DESIGN BULLETIN

1. Design bulletin no. DB/03/2013/07
2. Subject Modification in electrical circuit to avoid discharge of battery in Dual cab HHP locos due to Cab light & cab fan operation in both cab during locomotive shut down condition.

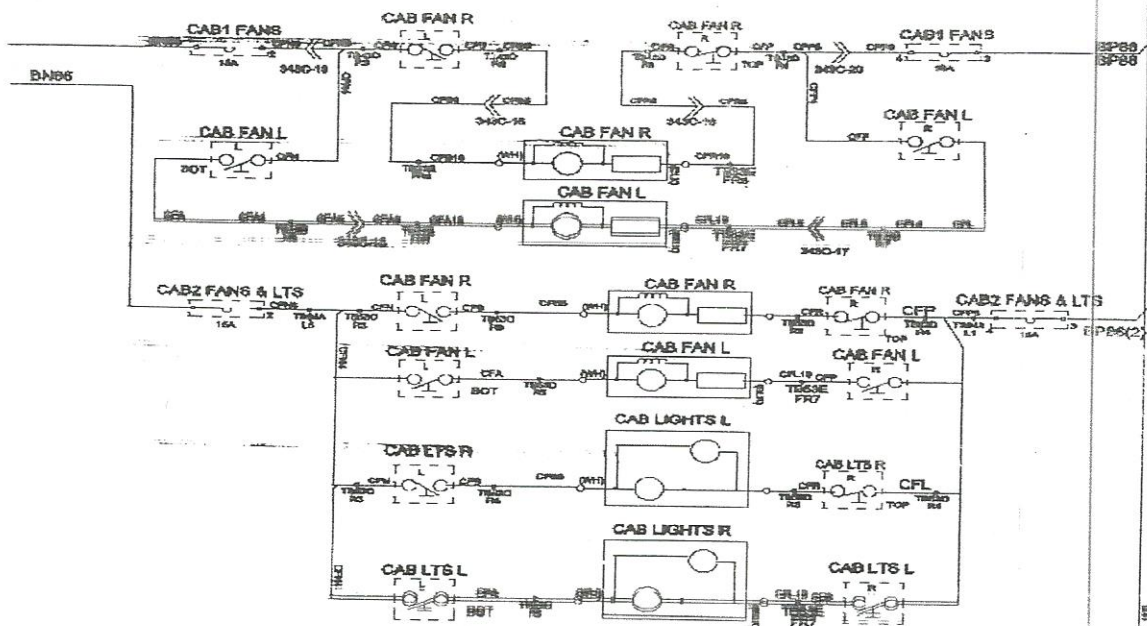
3. Background In the existing electrical circuit; Loco Cab fan & Cab light can be operated in both cabs at same time which causes deep discharging of battery in locomotive shut down condition, which cause problem in starting the locomotive.

4. Objective To avoid discharging of battery due to running of Cab Fan & Cab Light in both cab during locomotive shut down condition by making the interlocking through BL key.

5. Details of study/ Investigation CMPE/NWR vide their letter no M/233/301/medha dtd 19.09.13 has reported the problem of starting of locomotive in M/S Medha AC-AC traction equipped Dual cab HHP locomotives in BGKT/Shed. When the battery voltage of locomotive below 62 Volts and the start switch is moved from Prime to start position then display disappears for some time. Meanwhile if loco pilot release the start switch from loco start position then loco will not start.
On investigation, it has been found that, there is no any interlocking of (cab fan & light) for both cab and at the same time both cab fan and light may be switched ON, which causes deep discharging of battery in locomotive shut down condition. There is also possibility that the operating staff left the locomotive with running cab fans & lights in both cabs, which causes deep discharge of battery in shut down loco condition and loco starting problem occurs.

- 1506
6. Corrective action To avoid above discharging problem, (cab fan & cab light), circuit has been modified to interlock through BL key. In cab#1, cab fan can be operated when cab#1 made active through BL key. In cab#2, (cab fan & cab light) cab be operated when cab#2 made active through BL key. The Cab Light/Cab Fan circuit modification has been done in WDP4D-40168 at DLW. Modified circuit is enclosed as Annexure-A.
 8. Drg/Spec/Test plan/QP modified As per modified circuit.
 9. Implementation To be Implemented with Immediate effect in WDG4D/WDP4D Dual cab HHP locomotives
 10. Circulation M/s Medha Servo Drives Pvt. Ltd. Hyderabad, M/s Siemens India New Delhi, Dy.CME/Loco, Dy. CQAM, Zonal railways, Dir/MP/RDSO
